Findings, Conclusions and Decision Public Works Variance EN-22-0015

Site: The Reserve Preliminary Plat
Parcel No. 0222323134

Re: **(EN-22-0015)** The Reserve Preliminary Plat Joint Use Driveway - Public Works Variance Request

RE: The Reserve — CPH Project No. 0228-21-001
Request for Public Works Standards Variance for Joint Use Driveways
City of Gig Harbor Permit No. EN-22-0015

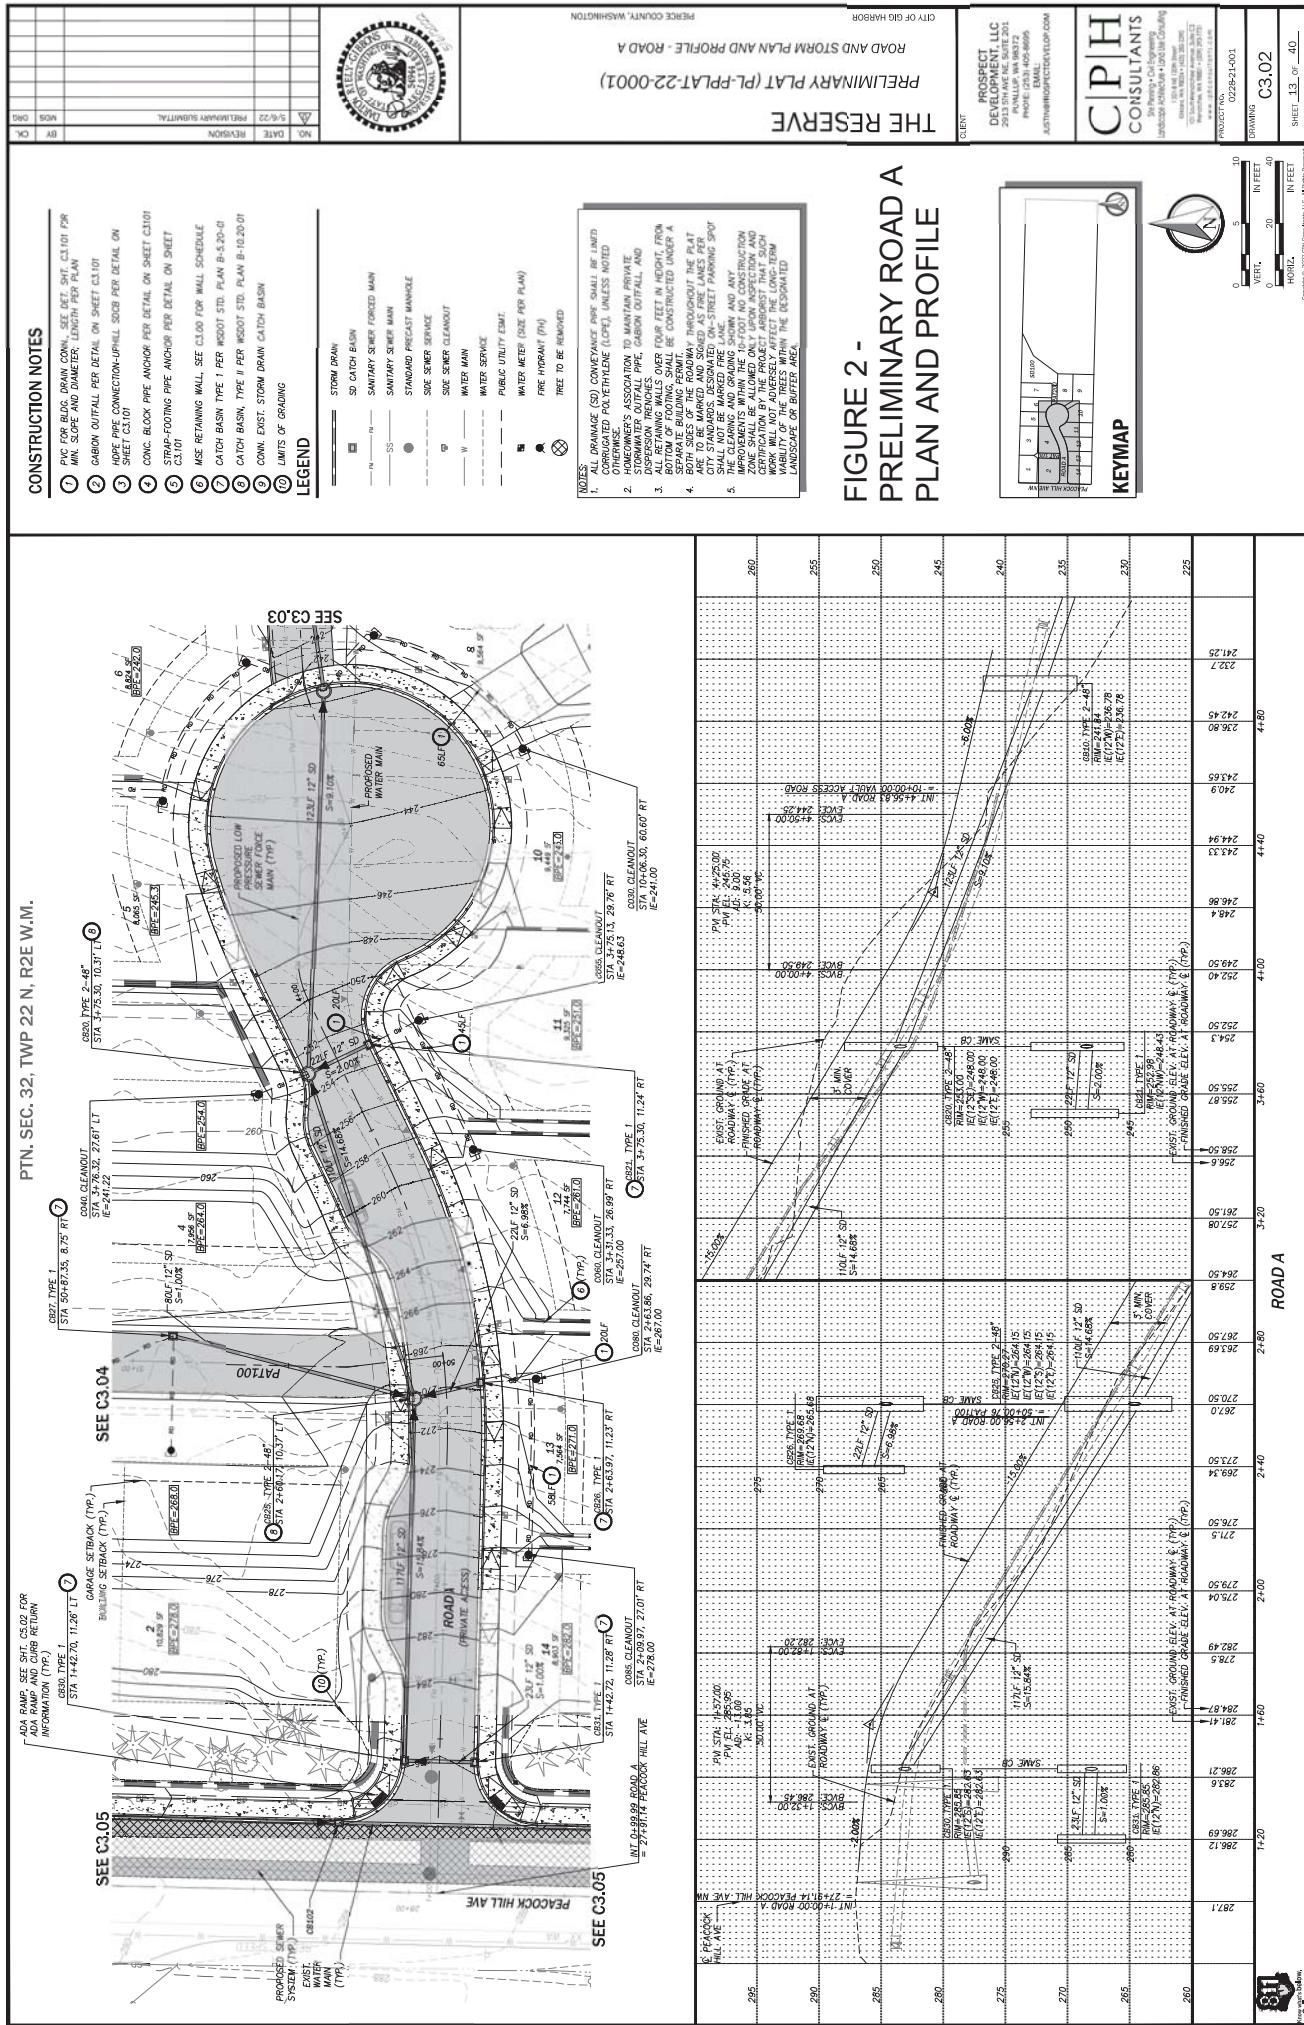
The proposed shared access and utility tract is oriented perpendicular to the private Road A and parallel with the site topography (see Figure 1). This provides a more convenient and safe access condition for these four lots and allows for more optimal density of the site. For this project in particular, the resulting reduction in the number driveways accessing the steep private Road A is an improvement in public safety and public infrastructure maintenance.

Having two separate joint-use driveways for Lots 1 and 2 and Lots 3 and 4 respectively would reduce the area available to accommodate such yard slopes. The configuration of these lots provides a practical solution to the challenge of site grades and a lot configuration that optimizes density. Individual driveways or separate joint-use driveways for Lots 1 through 4 would also result in the undesirable condition of increasing the number of driveways on the steep slope of Road A.

The City Engineer's analysis concurs with the Applicant's claim that the constraints created by the existing site conditions make it impractical due to reasons stated by the Applicant.

For the Reserve Preliminary Plat Joint Use Driveway Variance request, the Gig Harbor City Engineer concludes that the variance satisfies all the Criteria for Approval and therefore approves the variance request. Any modifications to the proposed development may nullify or require re-consideration of this approval, at the sole discretion of the City Engineer.

C TYPICAL SECTION - PAT100

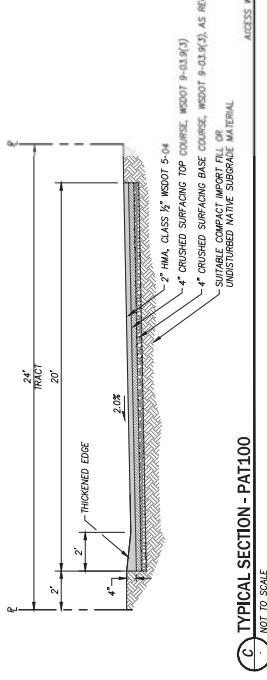
The use of a single joint use driveway to serve four lots will allow the use of a single-entry point for the four adjacent residential lots, thus reducing the number of driveways directly accessing the main path of travel. A joint use driveway was chosen as opposed to a private street in order to provide both vehicle and pedestrian access while also providing a narrower total width to facilitate grading. The proposed joint use driveway would utilize 20ft of pavement width. The use of a private street would require 22ft of pavement as well as 6ft of curb, gutter, and sidewalk on either side of the road resulting in a total of 34ft. This would reduce the amount of horizontal area that could be used to grade by a total of 14ft. It would also reduce the available usable yard space for each of the benefiting lots.

The City Engineer's analysis concludes that the Applicant has demonstrated that the proposed driveway configuration conforms with the intent of Section 2B.072 of the City of Gig Harbor Public Works Standards. The requested variance meets sound engineering practice as indicated.
